SERVICE BULLETIN

KODAK X-OMAT Processor

SERVICE BULLETIN NO. 214

Part Change for ROLLERS in the RACK ASSEMBLIES

Part Number Changes for the DEVELOPER RACK TURNAROUND ASSEMBLY on the *Kodak X-Omat M35 Processor, Kodak X-Omat M35A Processor, Kodak X-Omat M35G Processor, Kodak Industrex M35 Processor, and Kodak Industrex M35-A Processor*

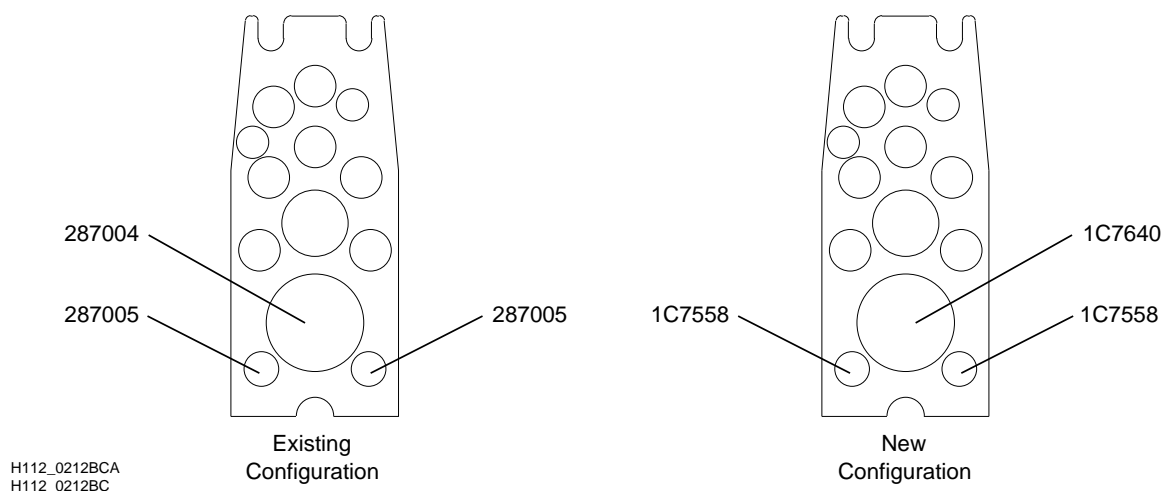
See Table 2 and the figure below for the part number changes in the DEVELOPER RACK TURNAROUND ASSEMBLY. The ASSEMBLY includes a 5.1 cm (2 in.) diameter MASTER ROLLER and two 2.5 cm (1 in.) diameter CLUSTER ROLLERS. When the replacement of any 1 of these 3 existing ROLLERS is necessary, you must install all 3 new ROLLERS at that time. The new configuration must be used for correct film transport.

After the 3 new ROLLERS have been installed the first time, install any future replacements individually.
